Docket Item # 2 & 3
BAR CASE # 2011-0191 & 0194

BAR Meeting
July 27, 2011

ISSUES: Permit to Demolish and Certificate of Appropriateness: fencing shutters, stoop alterations, and portico roof replacement

LOCATION: 315 Buchanan Street

Figure 1: Cohesive block face of 315 Buchanan Street (from left, 323, 321, 319, 317 and 319)

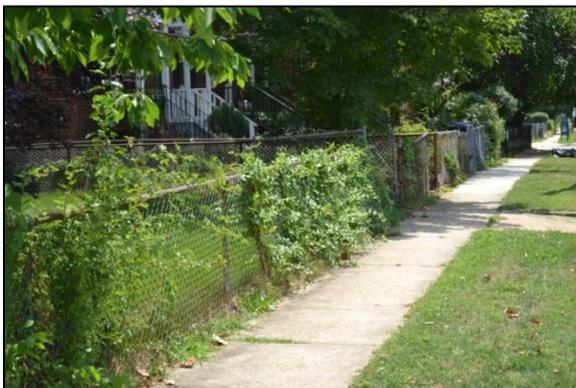
Staff does not support the after-the-fact installation of the 36" tall aluminum fence along the west and south property lines, as a chain-link fence is more historically appropriate for the subject property. The entire portion of Buchanan Street has a cohesive block face of chain-link and allowing the more high-style, late Victorian period aluminum fence would not be in keeping with the uniform character of the block or the Modernist/Colonial Revival style of the buildings. The aluminum fence that was installed is one that snaps together and is therefore, very delicate. While the aluminum fence is open and preserves the public view of the open front yard like chain-link does, the lack of weight and durability of the aluminum fence is not representative of this important characteristic of historic chain-link fences.

1. That a chain-link fence be reinstalled along the west and south portions of the property and that the fence be placed entirely on the subject property and not in the public right-of-way;
2. That no paver bricks are applied to the brick piers of the stoop;
3. That the wood shutters fit within the rowlock sills and concrete lintels so they do not obscure these character-defining features; That the shutters are hinged and operable (with final approval by Staff of hardware); and that the shutters are capable of covering the entire window opening when closed;
4. That the composition shingles be architectural grade per the Roof Materials Policy.

Figure 6: Example of the brick paver the applicant intends to use to cover the concrete portion of the stoop.

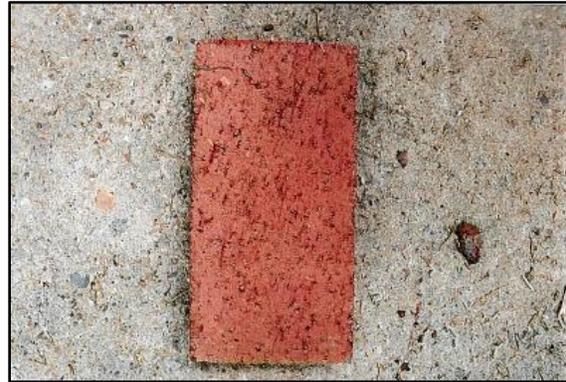
Staff believes that the only remaining original feature of the subject portico and stoop is the gable roof structure and the brick piers. Based on a survey of these row houses and other row houses of the same design within Old Town, Staff has determined the original design of the entries included a shed or a gable roof structure which alternated at each unit, wood support columns, wood landing, railings and steps, and brick piers. Other evidence of this design includes the paint ghost marks of earlier railings located on the building wall and a 1965 building permit which allowed replacement steps on the front of the house (at which time the wood railings and support columns were likely changed to metal). Staff is supportive of the applicants request to cover the concrete portion of the stoop with brick pavers so long as no pavers are applied to the brick piers, as these are an original feature of the row house. The applicant is intending to reuse the current metal railings and support columns.

Figure 15: Image showing three windows where proposed wood shutters will be installed.

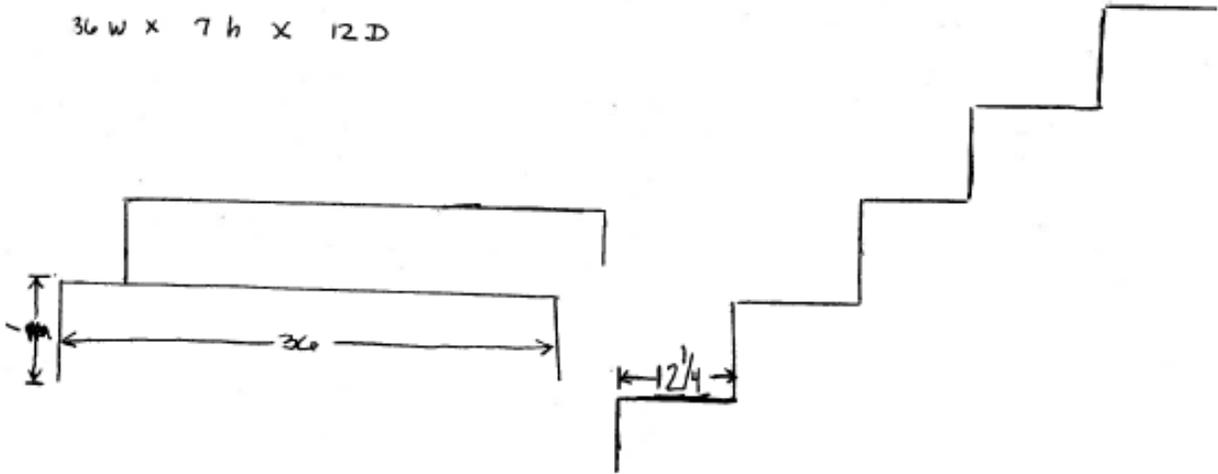
The subject row house is of the Colonial Revival style, on which shutters are common, and has single width window openings. While the addition of shutters will dress up the otherwise vernacular style structure and slightly obscure a portion of the brick quoin detailing, shutters are easily removable and therefore supported by Staff if they meet the following conditions: that they fit within the rowlock sills and concrete lintels so they do not obscure these character-defining features; that they are hinged and operable (with final approval of Staff of hardware); and that the shutters are capable of covering the entire window opening when closed.

Figure 16: Drawing showing dimensions for stoop and steps.

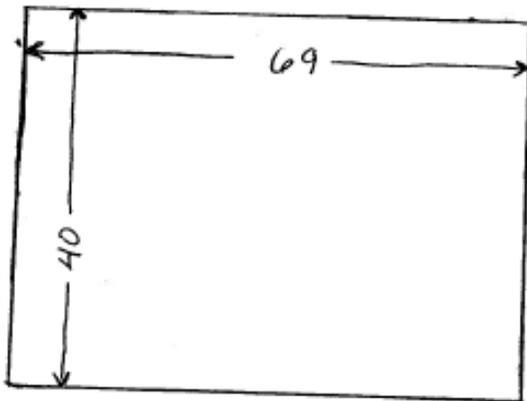
- C-1 No building permits are required for;
- The black aluminum fence. Less than 6' in height.
 - Apply shingle roof covering to the existing portico roof
- C-2 A building permit will be required to alter the stoop/step and for the erection of the wood fence at the rear of the property. In evaluating the permit application for the stoop alteration, the maximum riser height and minimum tread depth will be required to be met.

Figure 17: Side of gabled portico at 315 Buchanan.

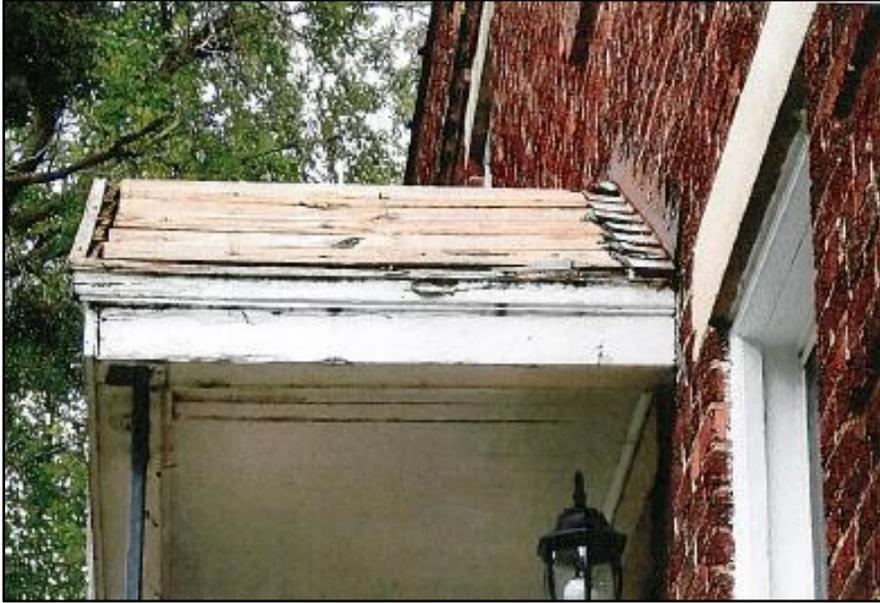
Based on the previously mentioned survey, Staff believes that the roofs of the porticos on these row houses were originally clad in composition shingles. The *Roof Materials Policy* states that “original composition roofing may be replaced with architectural grade composition roofing.” Staff recommends the use of architectural grade composition shingles for the roof cladding in a weathered wood or slate blend color.
